LINCOLN & DRANSFELDT

WATER AND SANITARY PLANS

ISSUE DATE: 08-16-2021	PROJECT #: 200829
DATE	REVISION COMMENTS
11-17-2021	PER PWSD COMMENTS

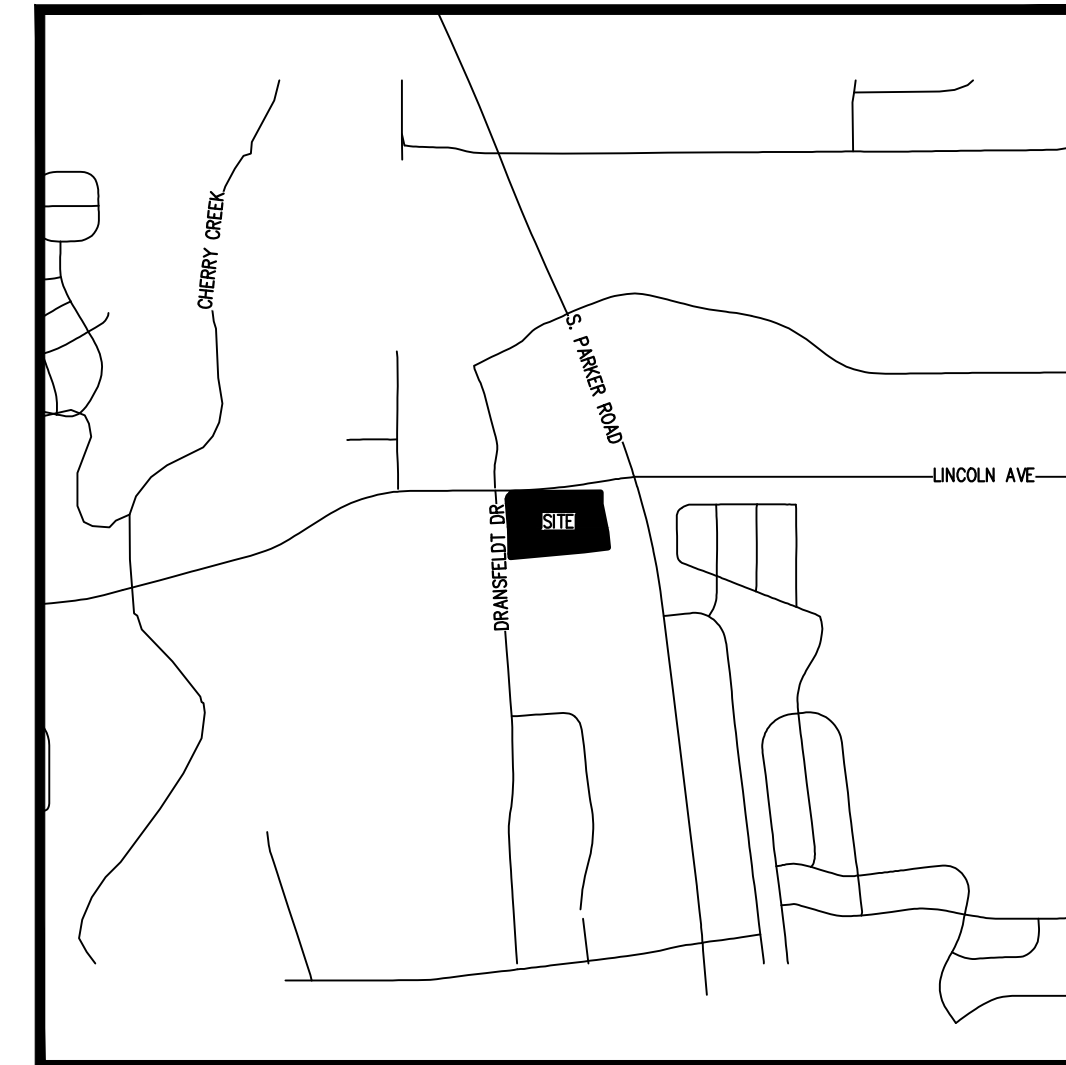
No Contact Information. Sheet Index and Agency Contact List. **This was requested on the on the checklist and has not been addressed**

Please add something like this

There are no PWSD details included in the plans. Please add all relevant PWSD details to the back of the Utility plans.

Addressed

Addressed

Addressed

LINCOLN & DRANSFELDT
OVERALL UTILITY PLAN

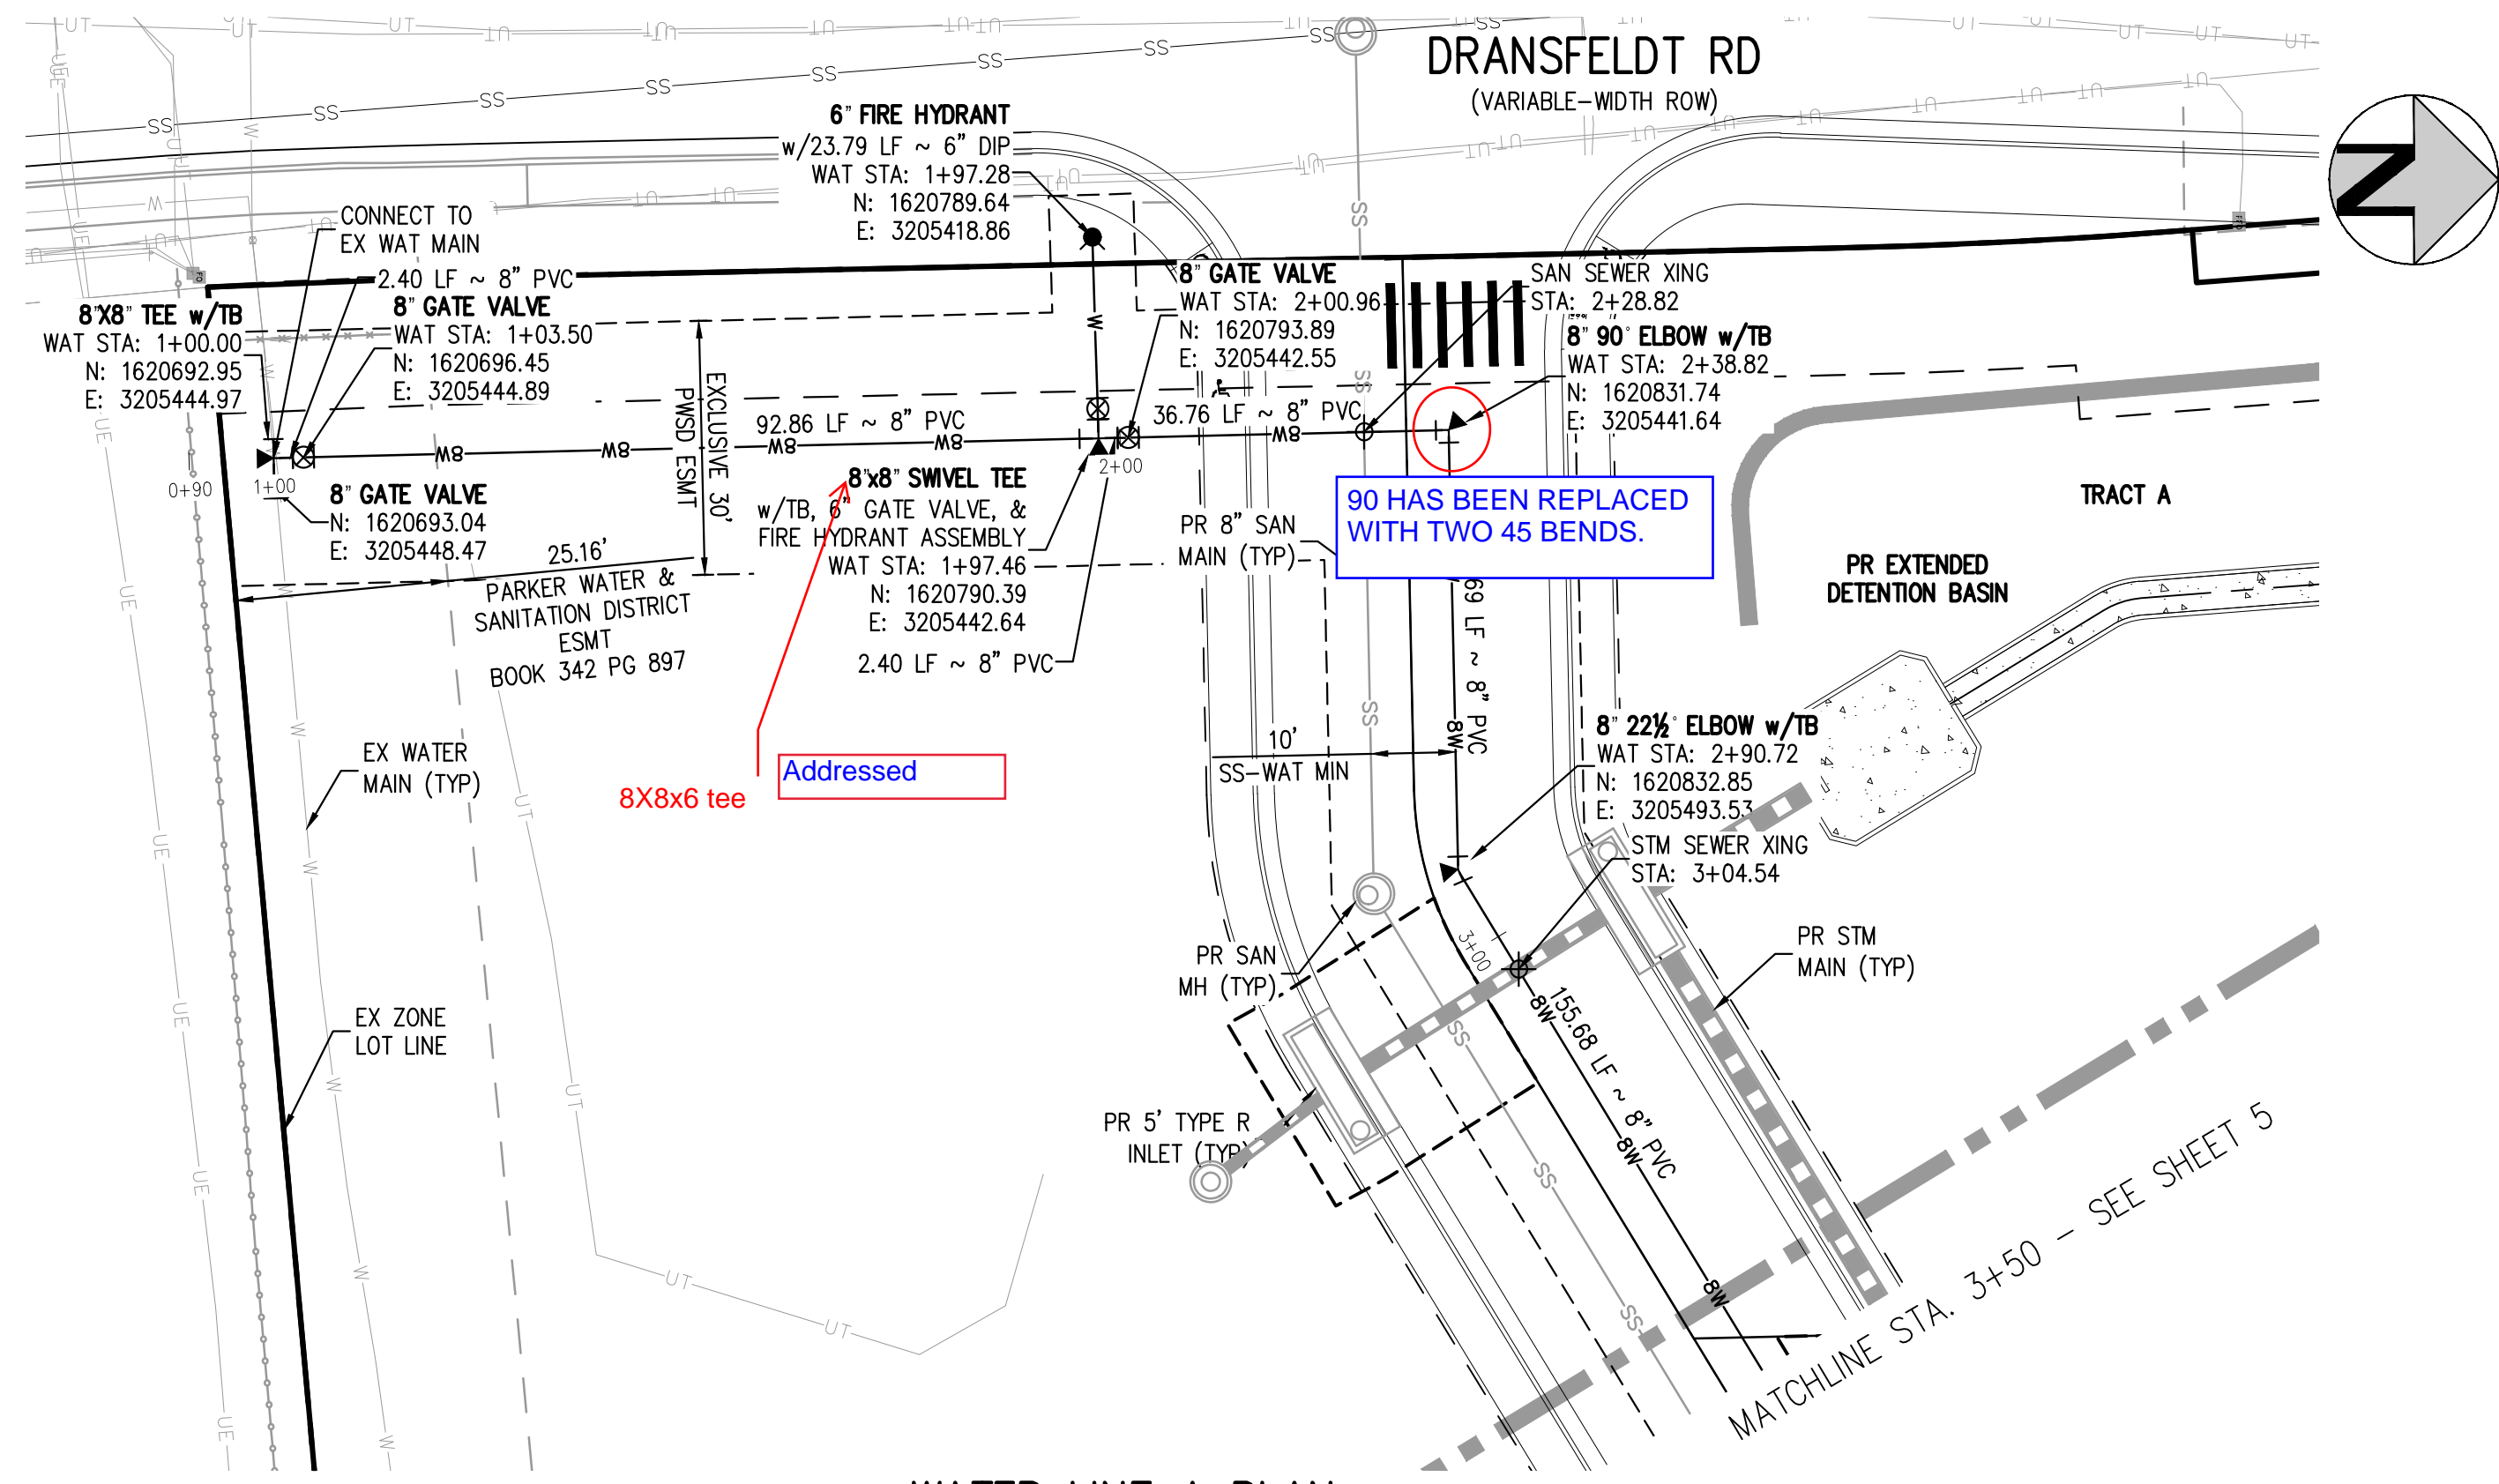
Why tie into this line. PWSD assumes the Town will require a bore across Lincoln. PWSD would rather have a tie into a different location.

Please consider tying in to this location instead to avoid bore.

LOT 1
This requires a 50ft easement. No easement is called out as requested in the previous comment letter. All proposed easements must be called out.

Add Two 45 degree bends instead

No 90 degree bend

No 90 degree bend

ADDITIONAL SURVEY WILL BE NEEDED TO CONSIDER OTHER LOCATION, WILL BE UPDATED WITH NEXT SUBMITTAL.

ADDITIONAL SURVEY WILL BE NEEDED TO CONSIDER OTHER LOCATION, WILL BE UPDATED WITH NEXT SUBMITTAL.

ADDRESSED

TWO 45 BENDS ADDED.

NOTED.

NOTED.

TWO 45 BENDS ADDED.

LINCOLN & DRANSFELDT
WATER LINE B PLAN & PROFILE

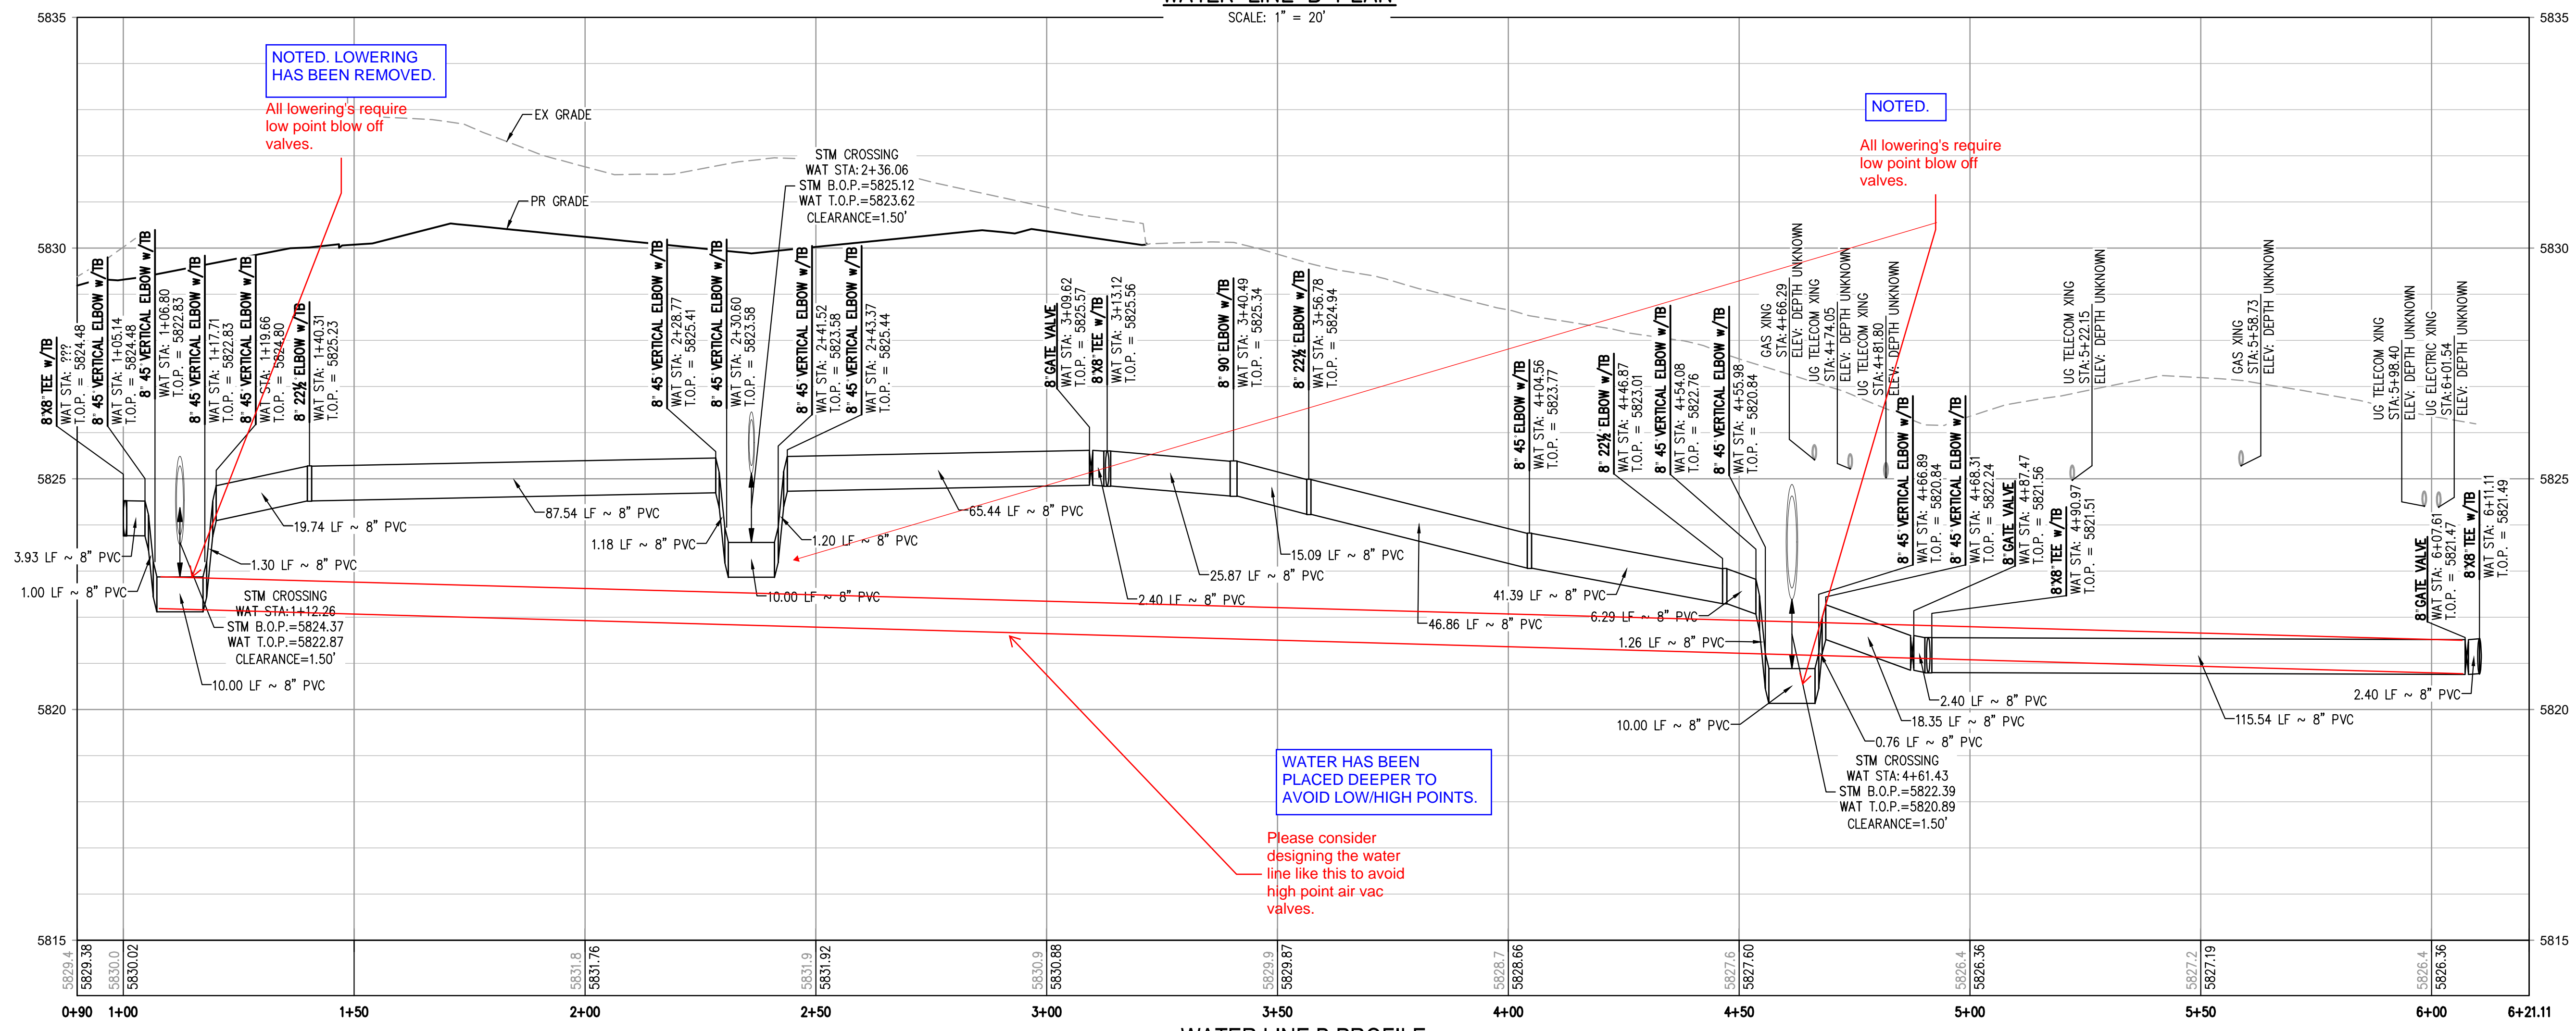
NOTED.
All lowering's require low point blow off valves.

Please consider designing the water line like this to avoid high point air vac valves.

NOTED. LOWERING HAS BEEN REMOVED.
All lowering's require low point blow off valves.

WATER HAS BEEN PLACED DEEPER TO AVOID LOW/HIGH POINTS.
